Hunter Water Corporation  
ABN 46 228 513 446

19 August 2014

**Submission: AIR 6000 Phase 2A/B New Air Combat Capability Facilities Project**

Annexure A – plan showing Hunter Water’s Critical Infrastructure and current registered easements

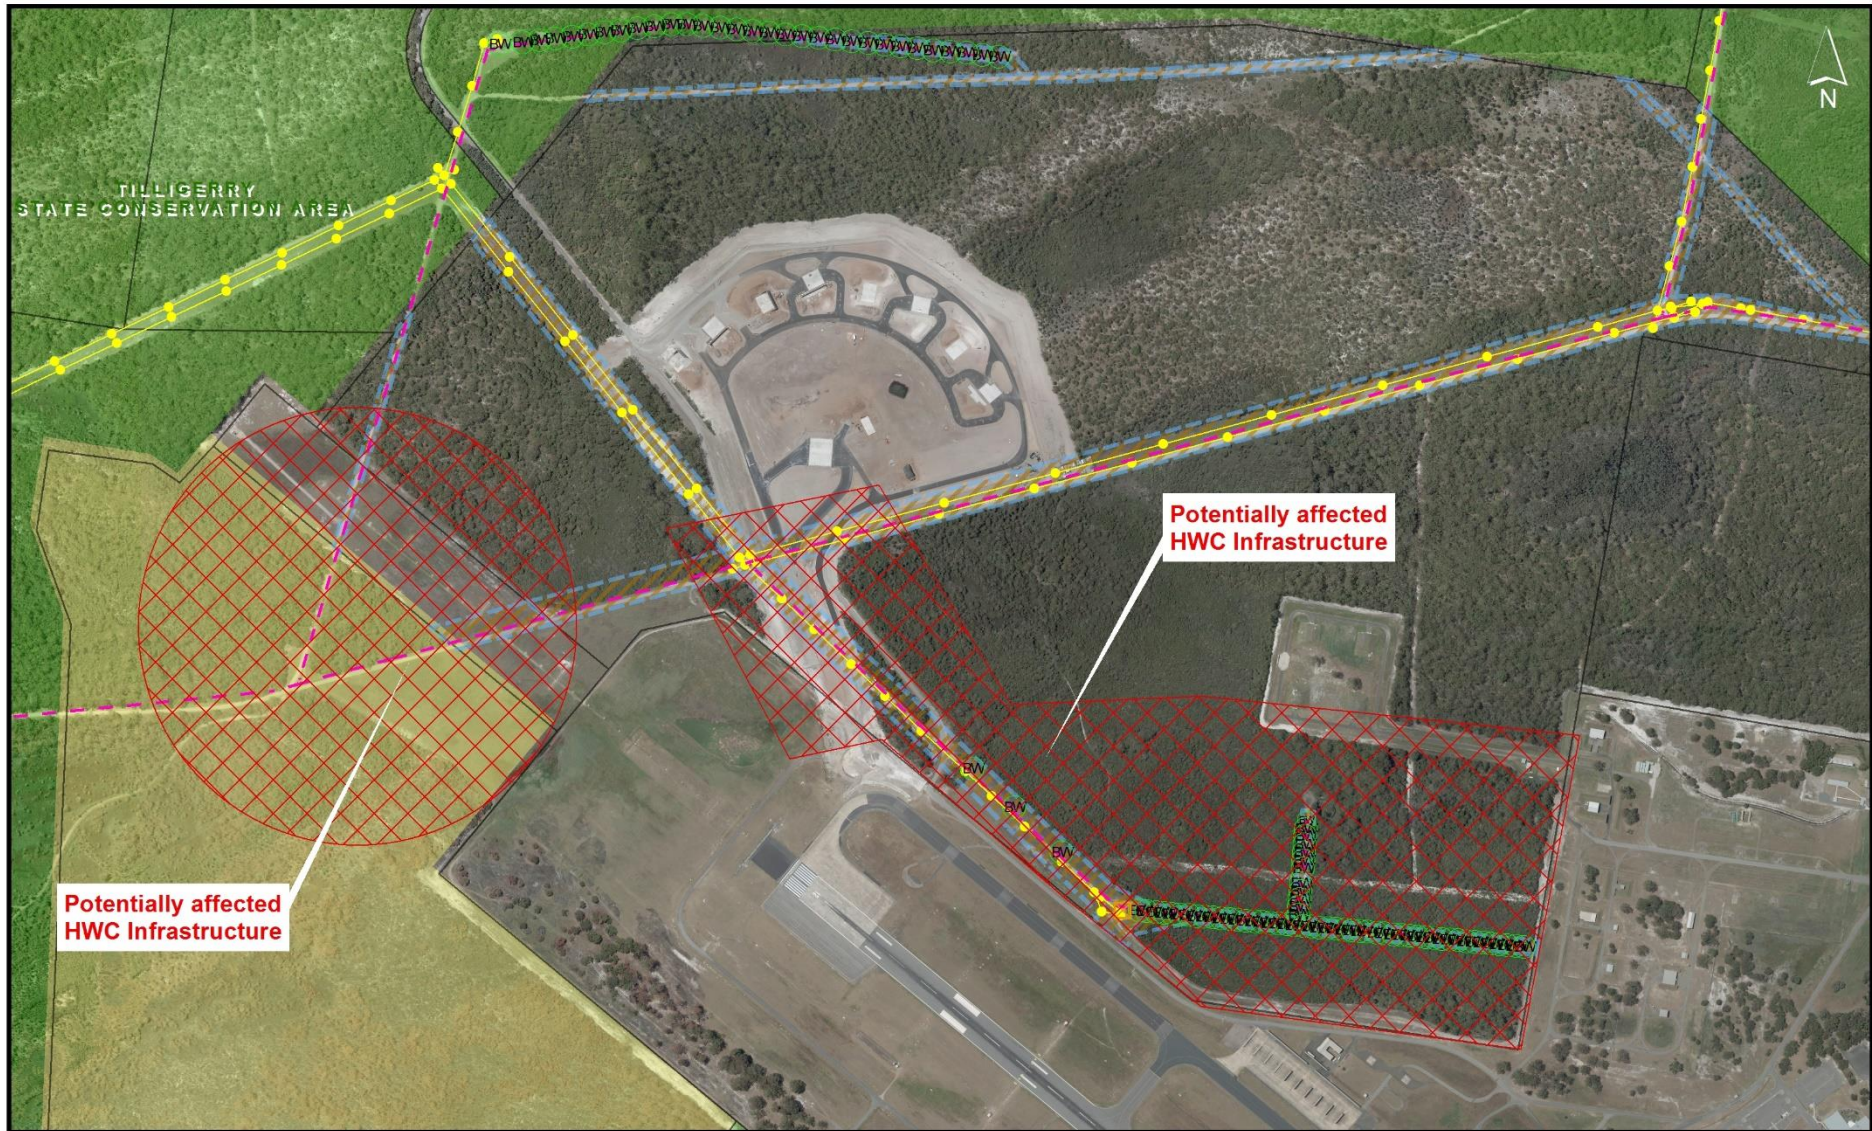
4. Hunter Water has extensive ground water extraction infrastructure within Defence land as shown on the plan at Annexure A, which is protected by registered easements and implied covenants under the *Hunter Water Act 1991* (NSW). There is currently unresolved easement issues surrounding the newly constructed ordnance facility which must be finalised prior to any further works being undertaken. See plan at Annexure B.

5. Defence must ensure access to Hunter Water's critical infrastructure is not impeded throughout the development phase and ongoing. This infrastructure remains critical to Hunter Water's ability to provide water to customers in the Lower Hunter.
